Draft Variation to the Territory Plan No 363 – Curtin group centre and adjacent residential areas

Submission Number: 002

Inquiry into Draft Variation to the Territory Plan 363 – Curtin
group centre and adjacent residential areas

Submission to the Inquiry into Draft Variation to the Territory Plan 363 – Curtin group centre and adjacent residential areas

Figure 9: Strangways Street (south) cross-section

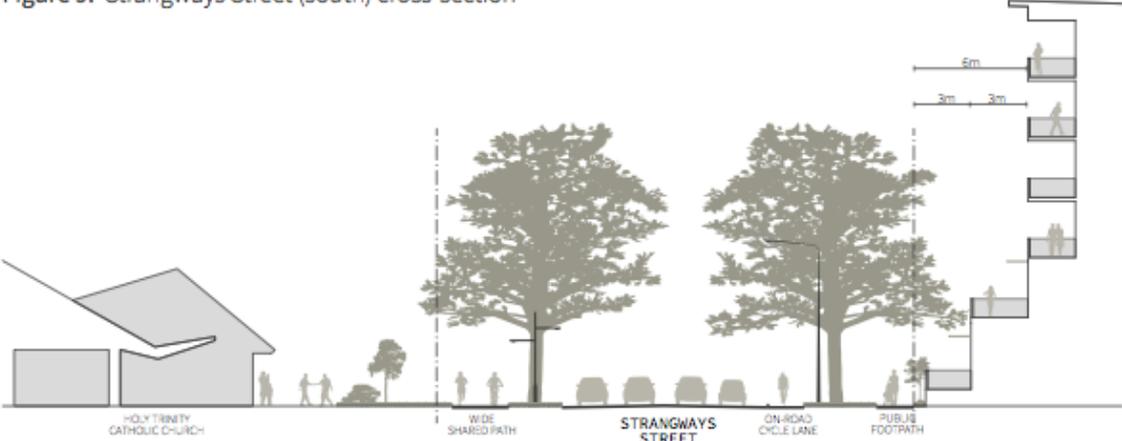
The cross-section of Strangways Street in Figure 9 on page 66 of the Curtin Group Centre Master Plan shows that a 3 metre setback for buildings is essential to enable planting of large canopy shade trees (those with a canopy diameter of 8 to 12 metres or more) with the existing road verge of approximately 6 metres.

Strangways Street cross-section (page 66, Curtin Group Centre Master Plan). This cross-section is in the area where the setback for commercial buildings should be 3 metres rather than the 0 metres in the recommended draft variation.

A setback that allows planting of large canopy shade trees would provide a consistent streetscape along the length of Strangways Street; help ameliorate the heat island effect in the Group Centre, which will be of increasing concern with climate change, and be consistent with Canberra’s Living Infrastructure Plan: Cooling the City, which is a component of the ACT’s climate change strategy. A setback of 3 metres is not inconsistent with commercial uses.

Consequently, all buildings in the area ‘C1’ in Figure 3 of the recommended version of the Curtin Precinct Code should have a 3 metre setback, irrespective of whether the use is residential or commercial.

R14(a) in the recommended version of the Curtin Precinct Code should be changed by deleting section (ii).

Figure 3 in the recommended version of the Curtin Precinct Code should be changed by removing the dotted line that indicates “0m setback permitted for commercial uses from block boundary at ground level”.
